ADDENDUM NUMBER: Four (4)

DATE: February 6, 2026

PROJECT: Interior Renovations for Montgomery County Assessor of Property

DESIGNER: DOUGLAS A. JONES, ARCHITECT
MONTGOMERY COUNTY ENGINEERING

E-2

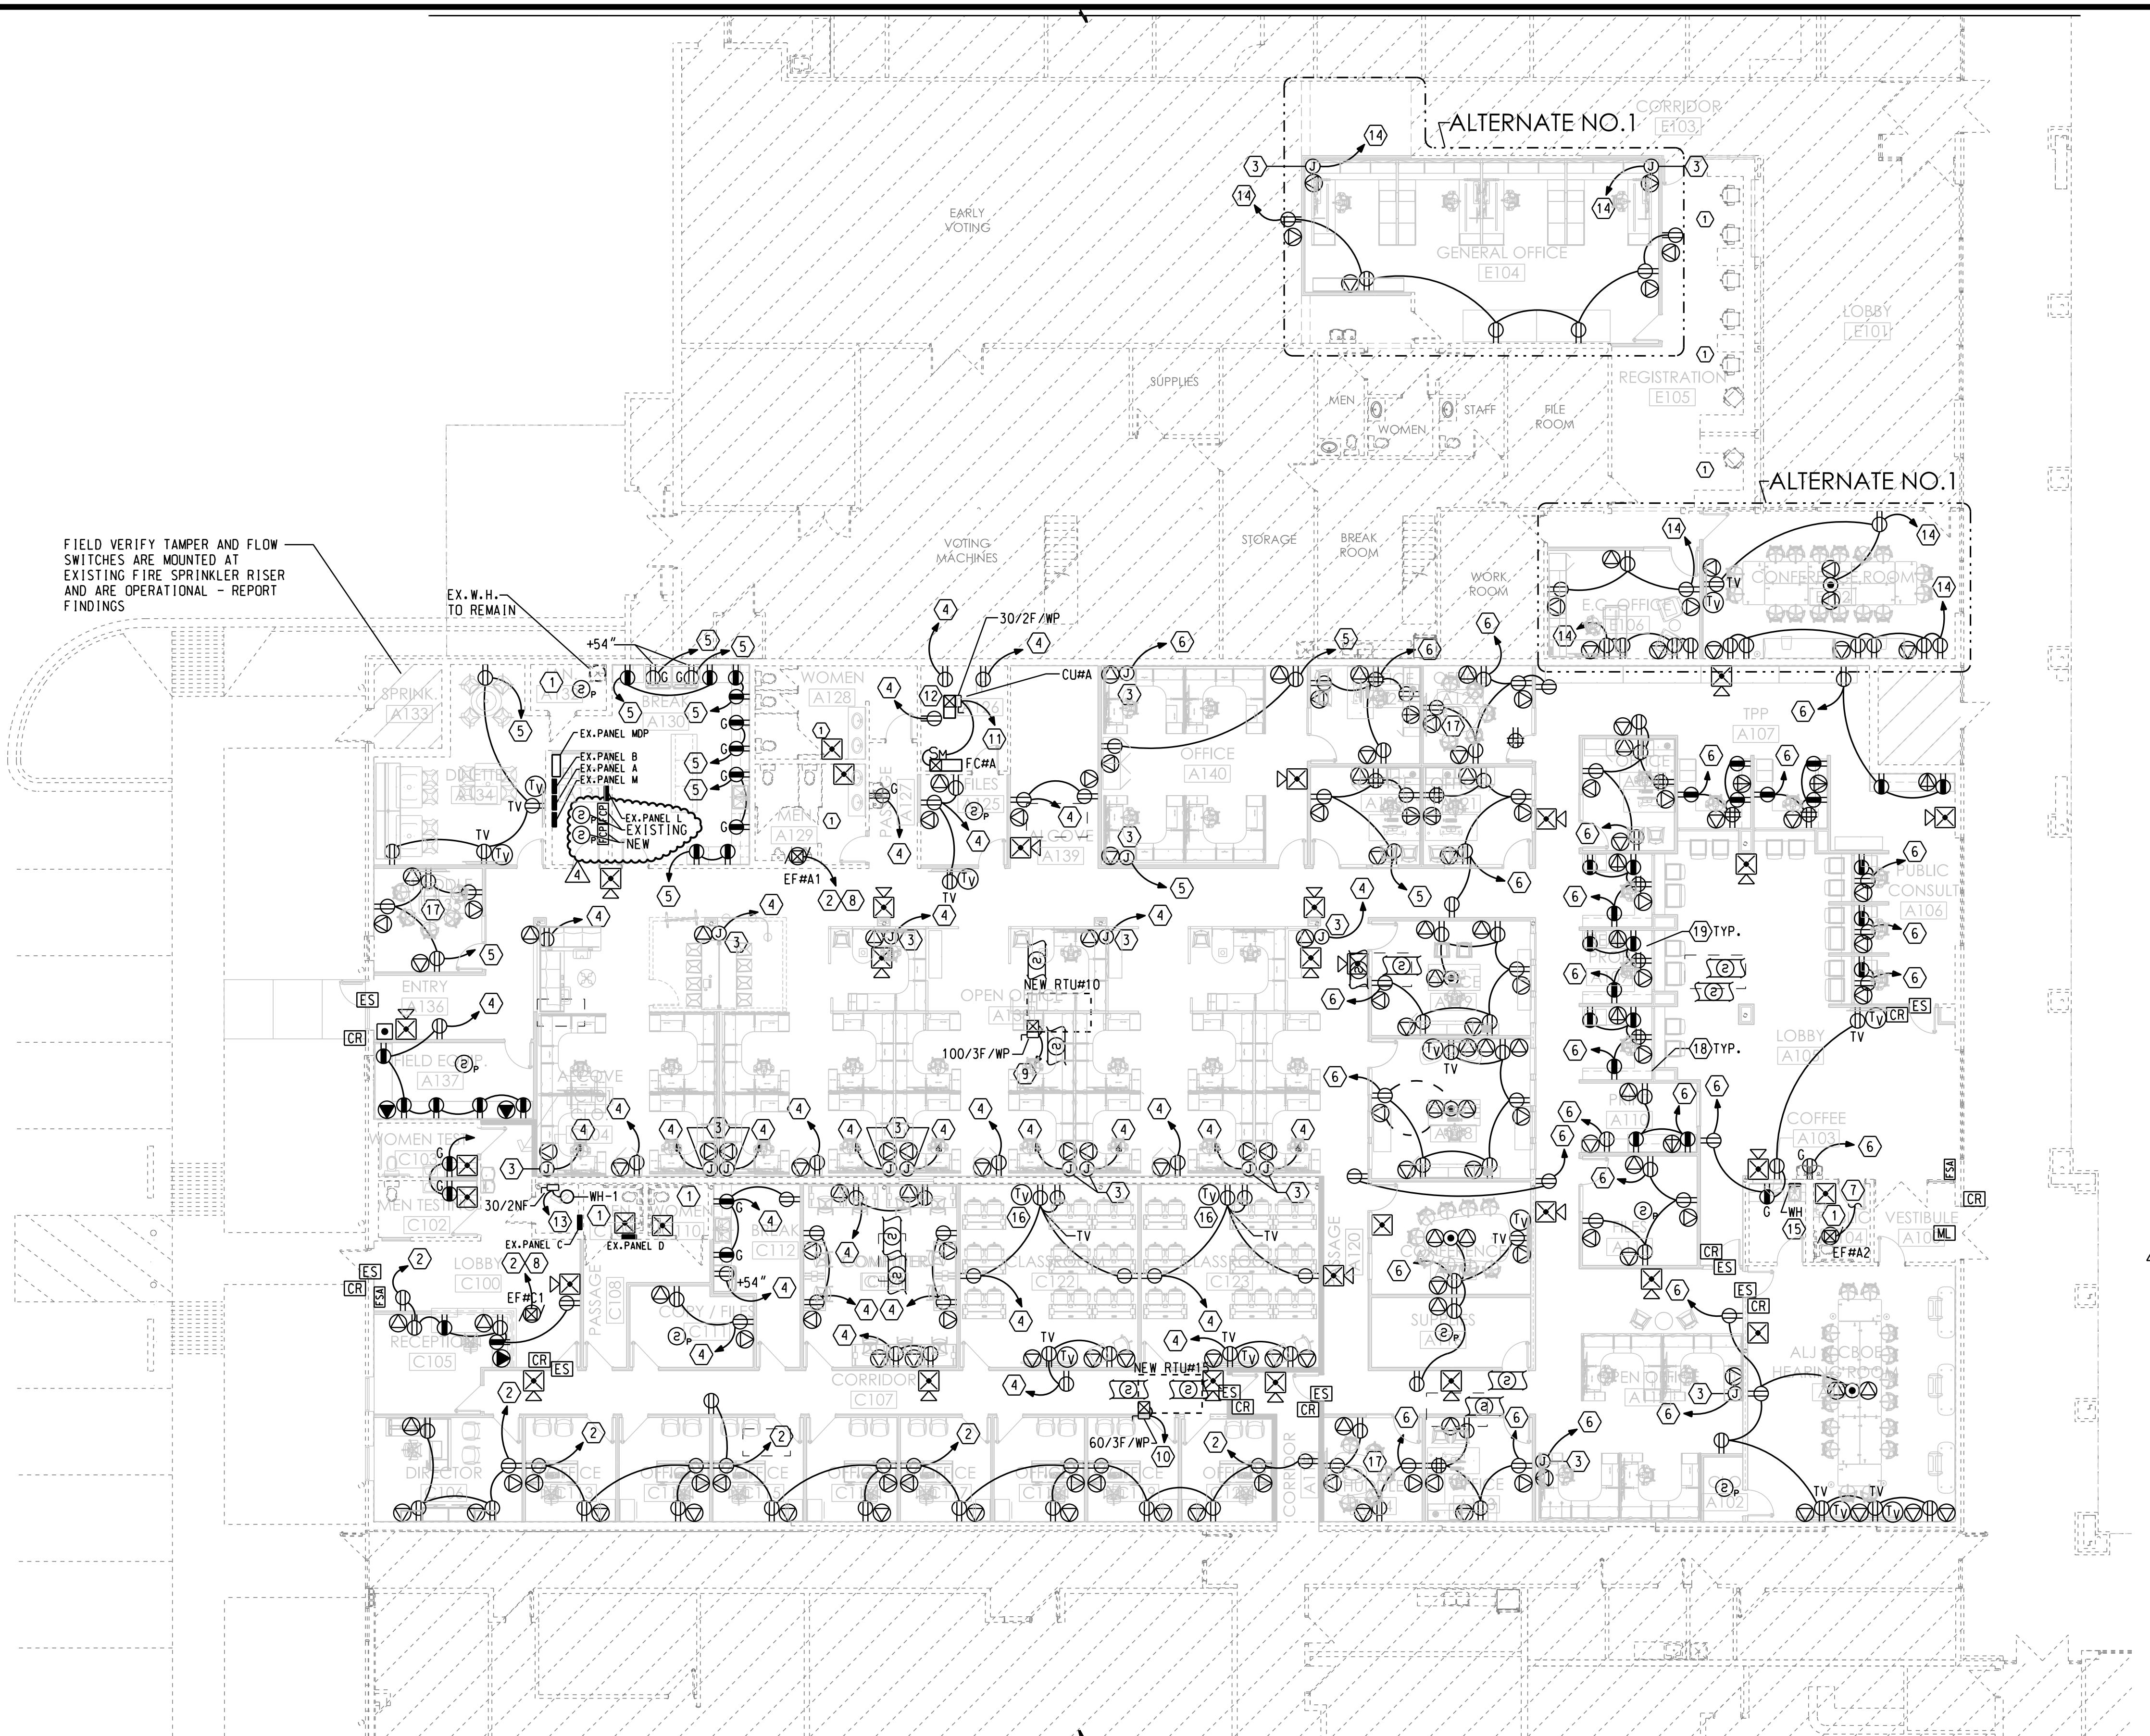
Addendum No. 03, Item 13 & SHEET E-2 POWER/SYSTEMS FLOOR PLAN; Delete Sheet E-2 dated 2/3/2026 and substitute therefor Sheet E-2 Dated 2/6/2026 attached hereto.

Clarification: Existing Fire Alarm system to remain & continue to serve Election Commission, VSO & IT. Provide New Fire Alarm system specified on sheet E-2 to serve Suites 401 & 402.

Q: Is the new fire alarm only in the scope of work area or will it be throughout the whole building?

Q: Do I need to include saw cutting, excavating of concrete, and patching of concrete floor for the floor boxes that are shown on page E-2?

A: After further investigation, the existing Potter 300 system serving Suites 401 & 402 also serves Suite 404 Election Commission, Suite 405 Veterans Service Organization, & Suite 406 Information Technology. The Existing Potter 300 FA system shall remain and continue to serve those areas. Existing devices shall be removed from Suites 401 & 402 and returned to the Owner. The system specified on sheet E-2 shall serve Suites 401 & 402. Refer to Item 02 above.

A: The concrete demo is called out on sheet D1.1 & patching is detailed on sheet A1.2. This should be coordinated between subcontractor & and the general contractor.

- FIRE ALARM CONTRACTOR TO PROVIDE A NEW FIRE ALARM SYSTEM FOR SUITES 401 AND 402. ACCEPTABLE MANUFACTURERS ARE SIEMENS, FIRE-LITE, SIREN KNOB, FIRETEK, KIDDE, EDWARDS SYSTEMS, ETC. AND NOT FEIER. NEW FIRE ALARM SYSTEM TO DETECT AND REPLACE EXISTING POTTER P300 FIRE ALARM SYSTEM IN SUITES 401 AND 402. FIRE ALARM SYSTEM TO BE CAPABLE TO EXPAND INTO OTHER SUITES FOR FUTURE REPLACEMENT.

- EXISTING POTTER 300 FIRE ALARM SYSTEM TO REMAIN FOR SUITES 404 ELECTION COMMISSION, 405 VETERAN SERVICE AGENCY, AND 405 INFORMATION TECHNOLOGY. FIRE ALARM CONTRACTOR TO REMOVE ALL EXISTING POTTER FIRE ALARM DEVICES REMOVED FROM SUITES 401 AND 402 TO THE OWNER.
